Furnish all labor, materials and equipment and perform all work for Consolidated Medical Training Facility, McChord Air Force Base, Washington, in accordance with the attached Contract Clauses, Special Clauses, Technical Specifications and Drawings.

2. AMENDMENT/MODIFICATION NO.	3. EFFECTIVE DATE	4. REQUISITION/PURCHASE REQ. NO.	5. PROJECT NO. (If applicable)
0002	08/09/99	W68MD9-9141-0915	PQWY 98-9002

A. This amendment provides for modifications to drawings plates, deletion of specifications sections, miscellaneous minor revisions to specification sections, revisions to Section 00800, and revision of General Wage Decision WA990002, as follows:

SKETCH NO: S-1

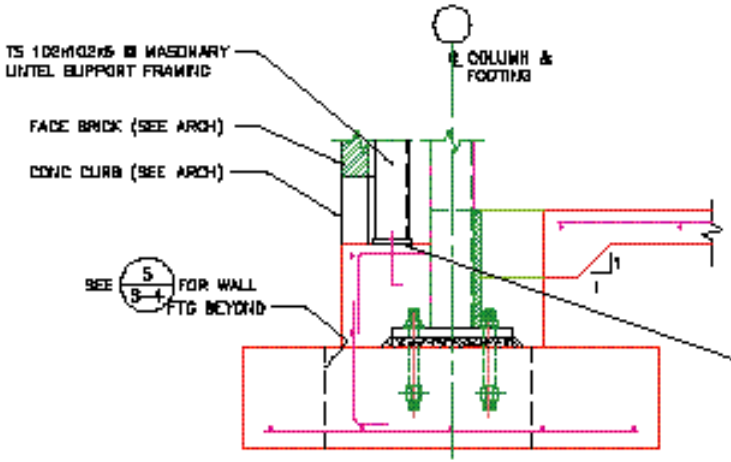
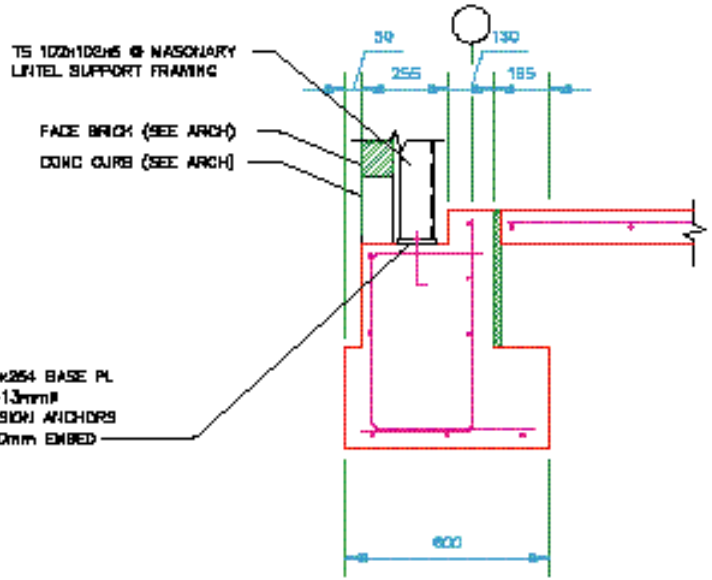
NOTE:
COORDINATE W/ARCH FOR LOCATION OF WIDE STEM WALL

BERGER/ABAM ENGINEERS INC.	McCHORD AIR FORCE BASE AIR MOBILITY COMMAND TACOMA WASHINGTON	
PREPARED BY: K. HAGHIGHI APPROVED BY: J. FEENEY	PROJECT NAME: CONSOLIDATED MEDICAL TRAINING FACILITY AMENDMENT NO: R0002	SKETCH NO: S-2

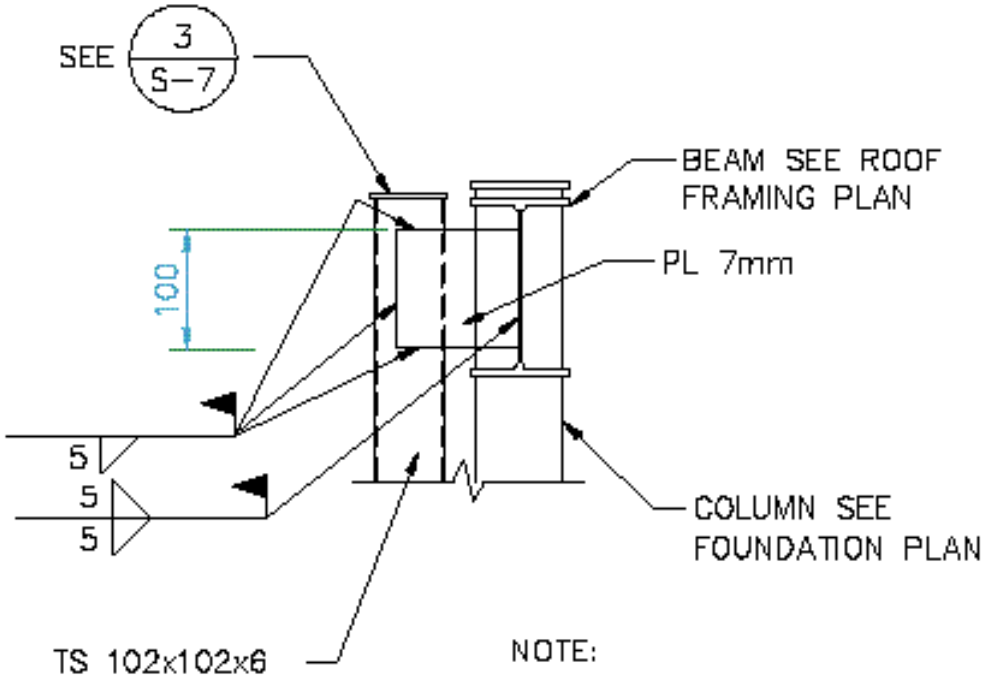
NOTE:
BRACE MASONARY LINTEL SUPPORT FRAMING COLUMN TO ADJACENT COLUMN OR BEAM @ ROOF LEVEL. TYP. FOR ALL COLUMNS.

BERGER/ABAM ENGINEERS INC.	McCHORD AIR FORCE BASE AIR MOBILITY COMMAND TACOMA WASHINGTON	
PREPARED BY: L. DAVENPORT APPROVED BY: J. FEENEY	PROJECT NAME: CONSOLIDATED MEDICAL TRAINING FACILITY AMENDMENT NO: R0002	SKETCH NO: B

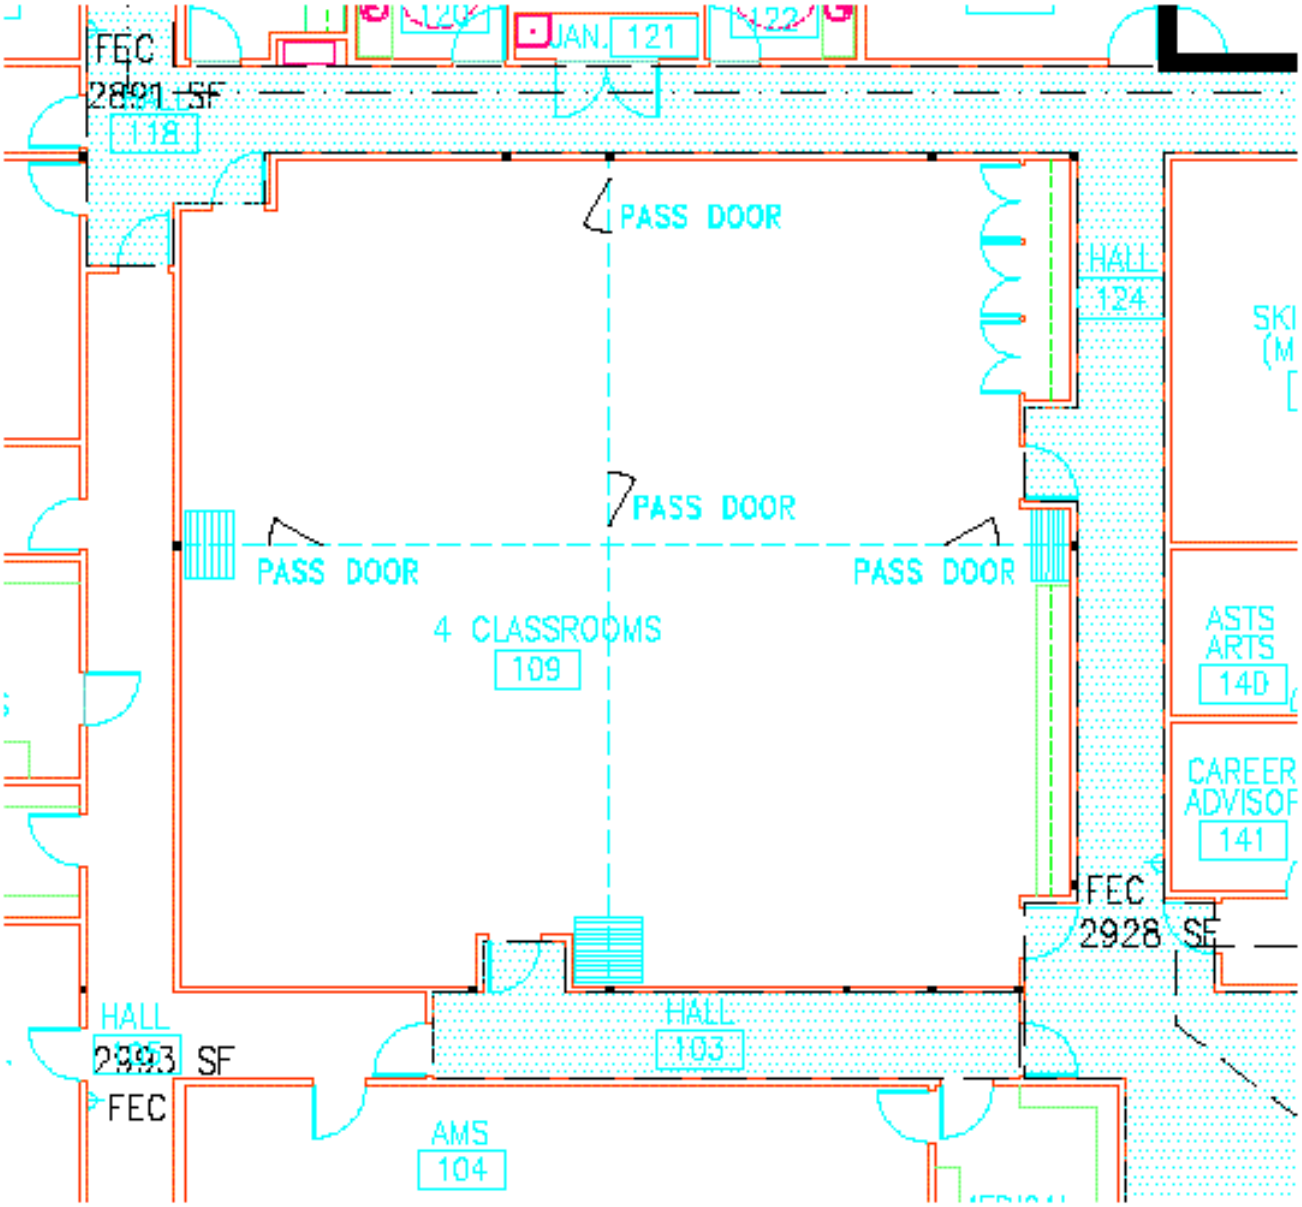
- Plate A-18: Replace Detail A1 with detail on Sketch 'B.'

BERGER/ABAM ENGINEERS INC.	McCHORD AIR FORCE BASE AIR MOBILITY COMMAND TACOMA WASHINGTON	
PREPARED BY: L. DAVENPORT APPROVED BY: J. FEENEY	PROJECT NAME: CONSOLIDATED MEDICAL TRAINING FACILITY AMENDMENT NO: R0002	SKETCH NO: C

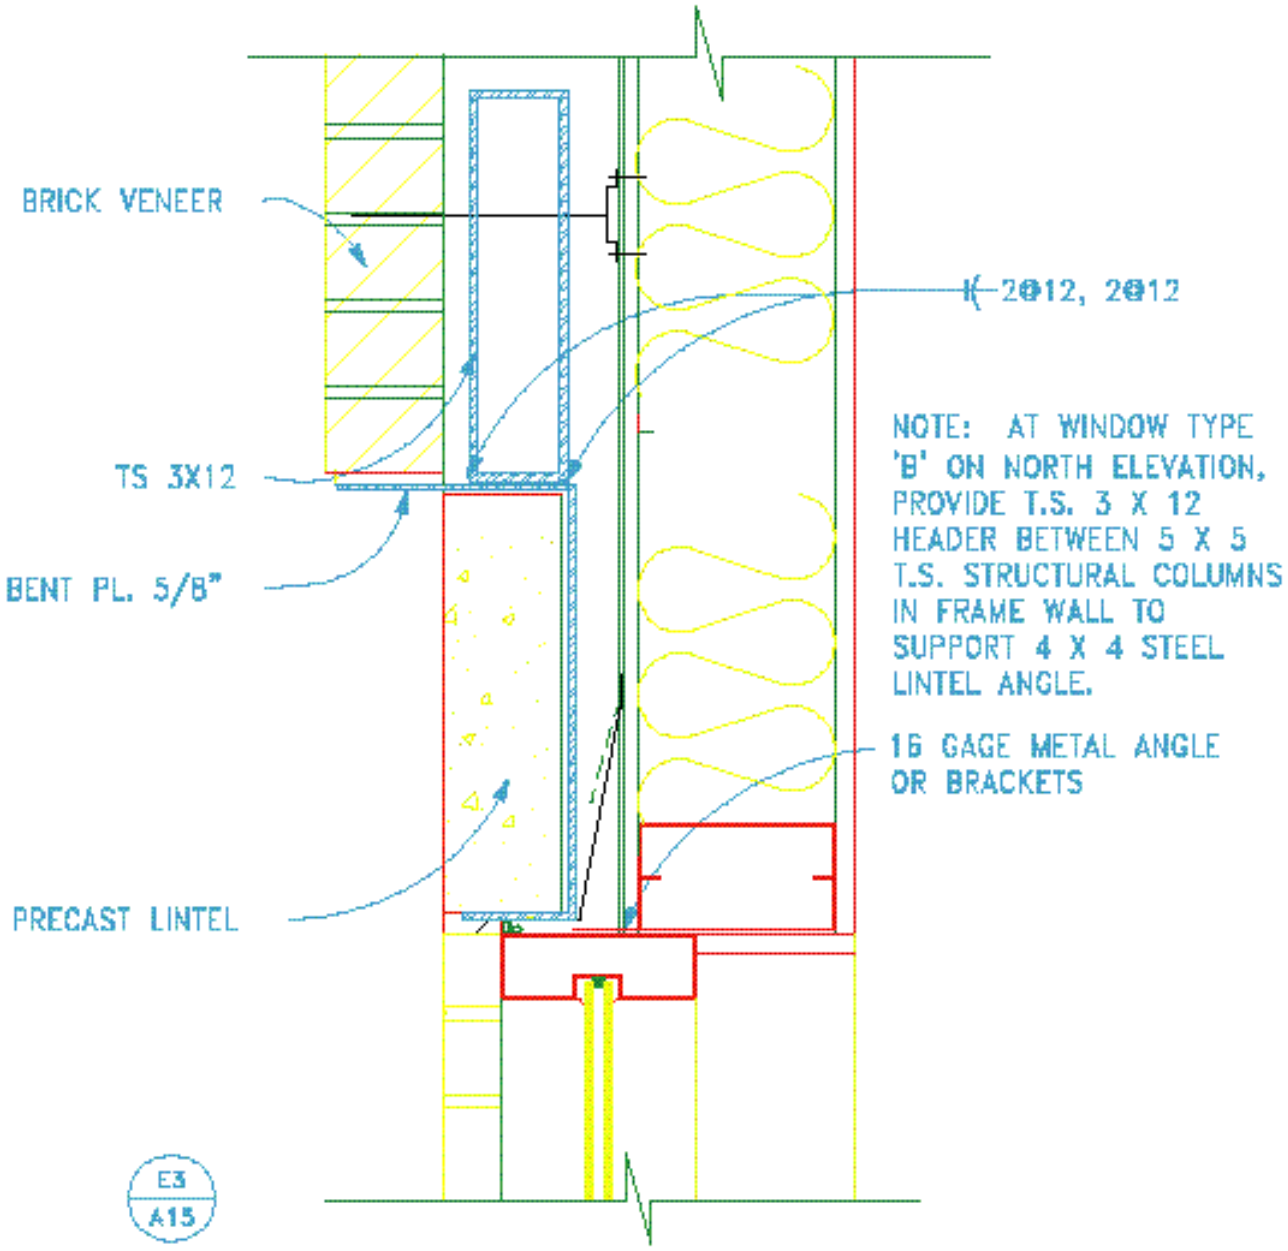
- Plate A-2: In the FLOOR PLAN revise Room 109 in accordance with Sketch C to show locations of pass doors in the operable partitions. Provide pass doors at the locations shown.

BERGER/ABAM ENGINEERS INC.	McCHORD AIR FORCE BASE AIR MOBILITY COMMAND TACOMA WASHINGTON	
PREPARED BY: L. DAVENPORT APPROVED BY: J. FEENEY	PROJECT NAME: CONSOLIDATED MEDICAL TRAINING FACILITY AMENDMENT NO: R0002	SKETCH NO: D

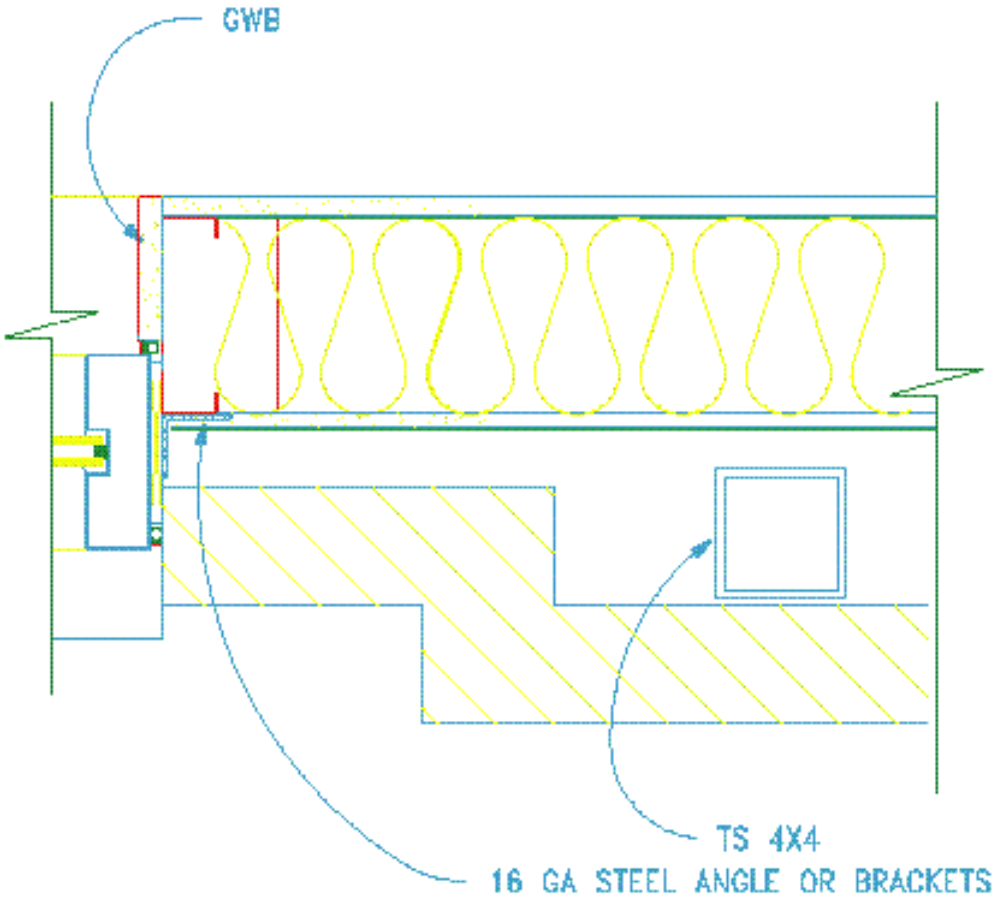
- Plate A-15: Detail E3 - Provide structural support of precast concrete lintels and brick veneer at window heads and backing for attachment of windows in accordance with details on Sketch'D.'

NOTE: AT WINDOW TYPE 'B' ON NORTH ELEVATION, PROVIDE T.S. 3 X 12 HEADER BETWEEN 5 X 5 T.S. STRUCTURAL COLUMNS IN FRAME WALL TO SUPPORT 4 X 4 STEEL LINTEL ANGLE.

BERGER/ABAM ENGINEERS INC.	McCHORD AIR FORCE BASE AIR MOBILITY COMMAND TACOMA WASHINGTON	
PREPARED BY: L DAVENPORT APPROVED BY: J. FEENEY	PROJECT NAME: CONSOLIDATED MEDICAL TRAINING FACILITY AMENDMENT NO: R0002	SKETCH NO: E

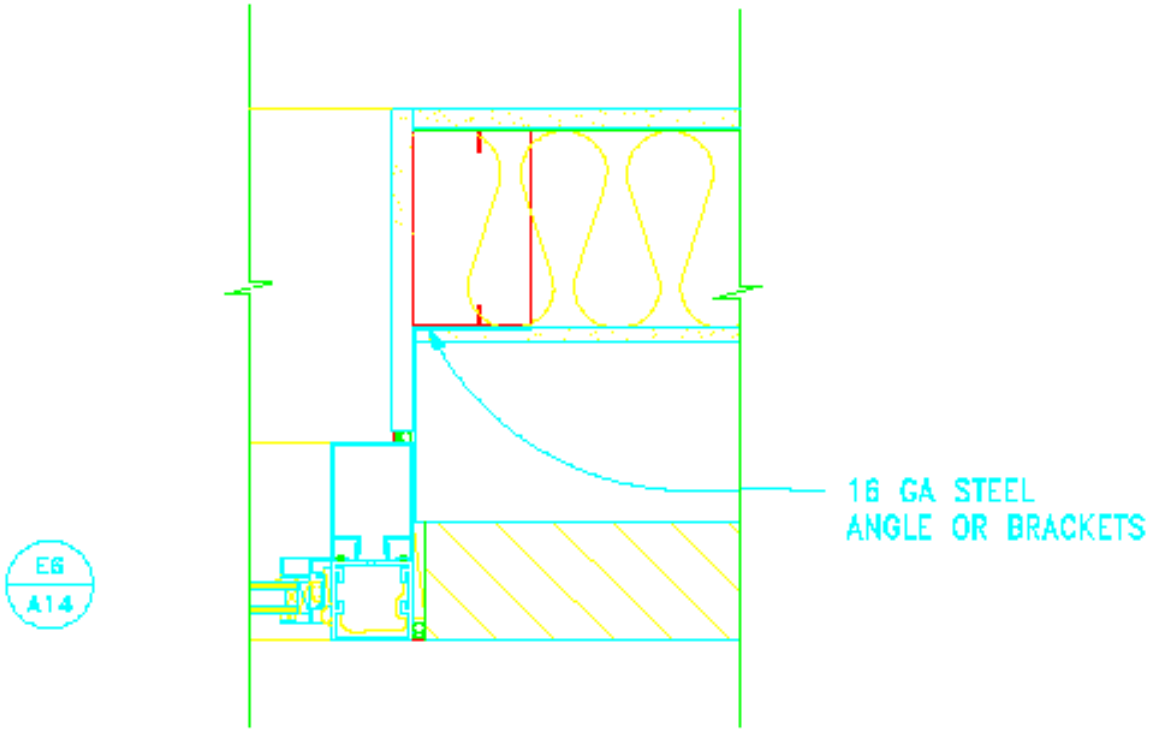
- Plate A-17: Delete Detail G3 – replace with detail on Sketch 'E.'

BERGER/ABAM ENGINEERS INC.	McCHORD AIR FORCE BASE AIR MOBILITY COMMAND TACOMA WASHINGTON	
PREPARED BY: L. DAVENPORT APPROVED BY: J. FEENEY	PROJECT NAME: CONSOLIDATED MEDICAL TRAINING FACILITY AMENDMENT NO: R0002	SKETCH NO: F

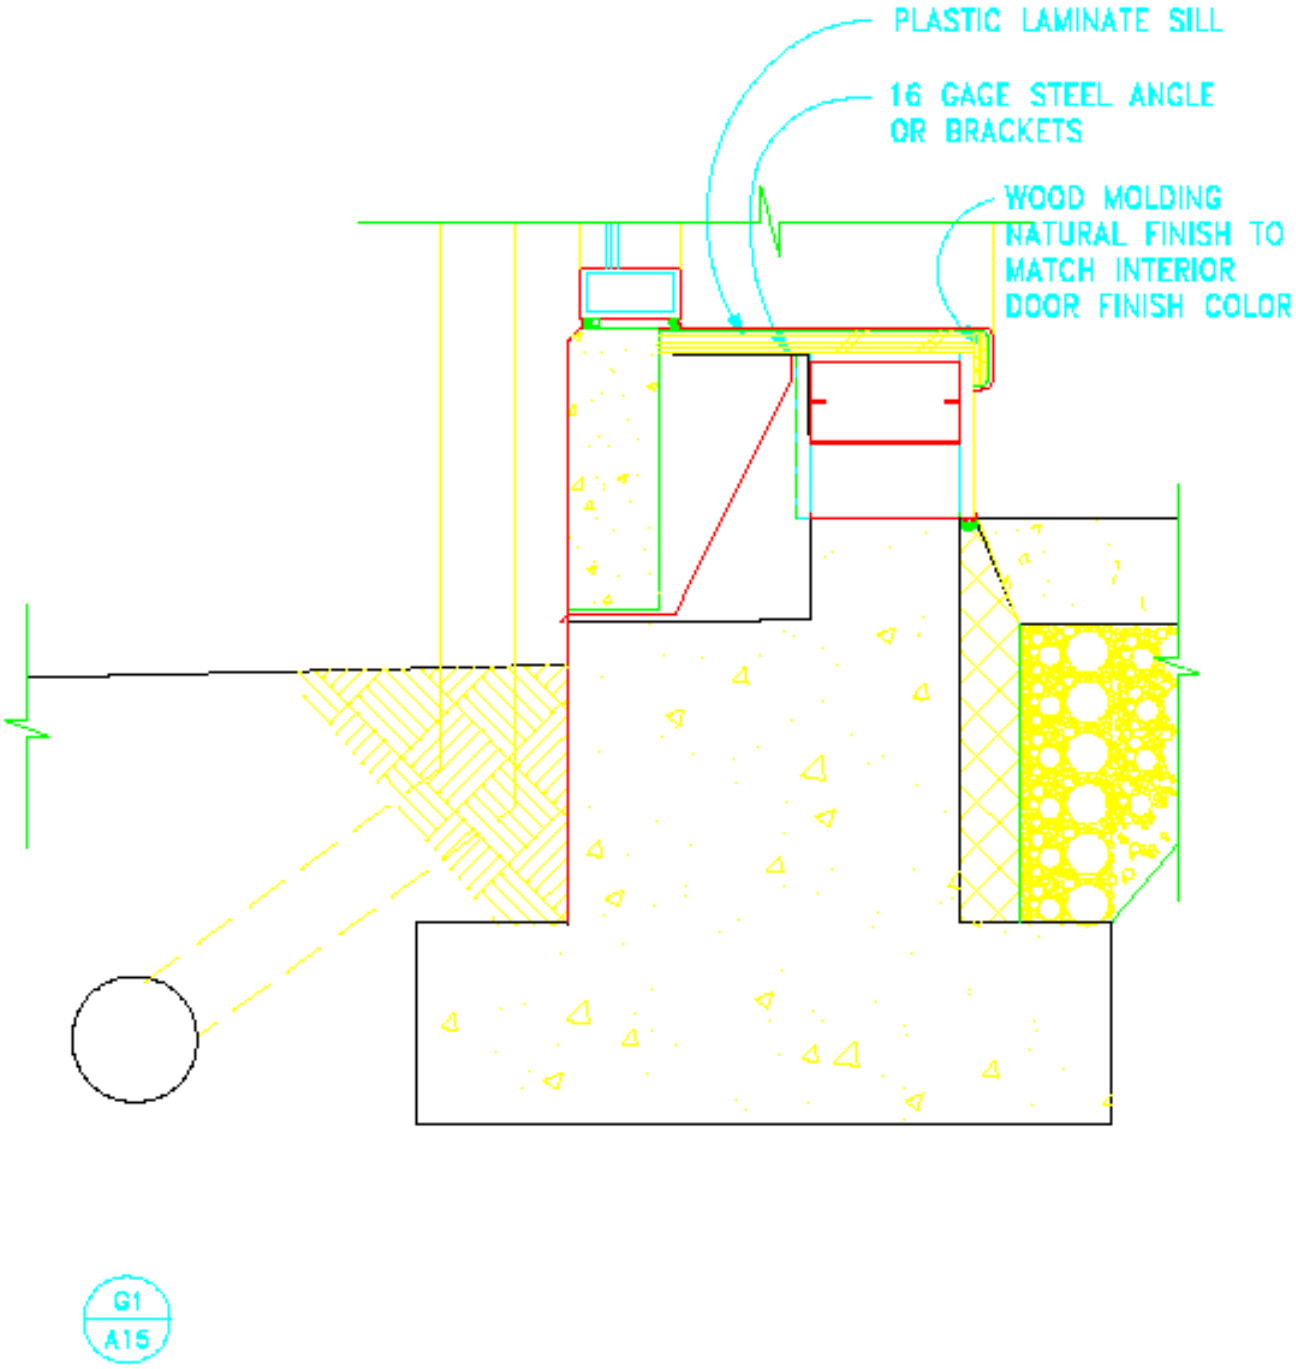
- Plate A-14: Detail E6 – Delete and replace with detail on Sketch 'F.'

- Plate A-15: Delete Detail G1 – replace with detail on Sketch 'F.'

BERGER/ABAM ENGINEERS INC.	McCHORD AIR FORCE BASE AIR MOBILITY COMMAND TACOMA WASHINGTON	
PREPARED BY: L. DAVENPORT APPROVED BY: J. FEENEY	PROJECT NAME: CONSOLIDATED MEDICAL TRAINING FACILITY AMENDMENT NO: R0002	SKETCH NO: G

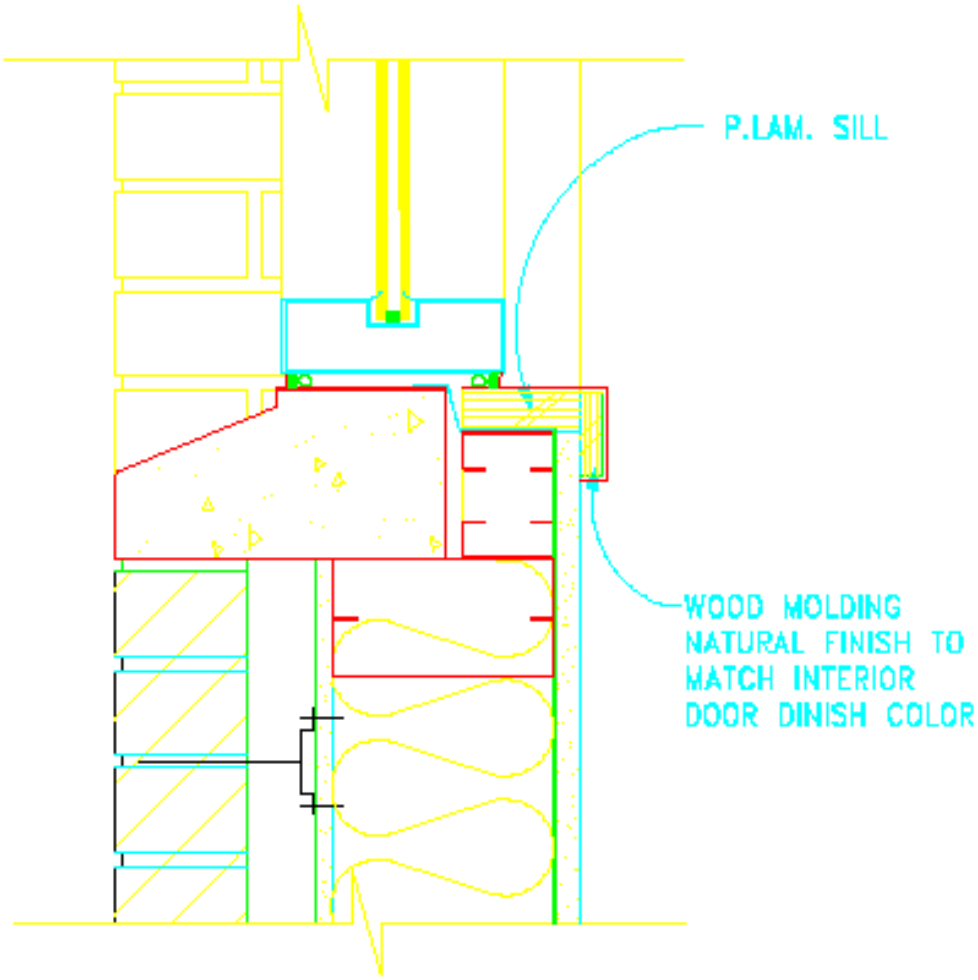
- Plate A-16: Delete Detail B6 – replace with detail on Sketch 'G.'
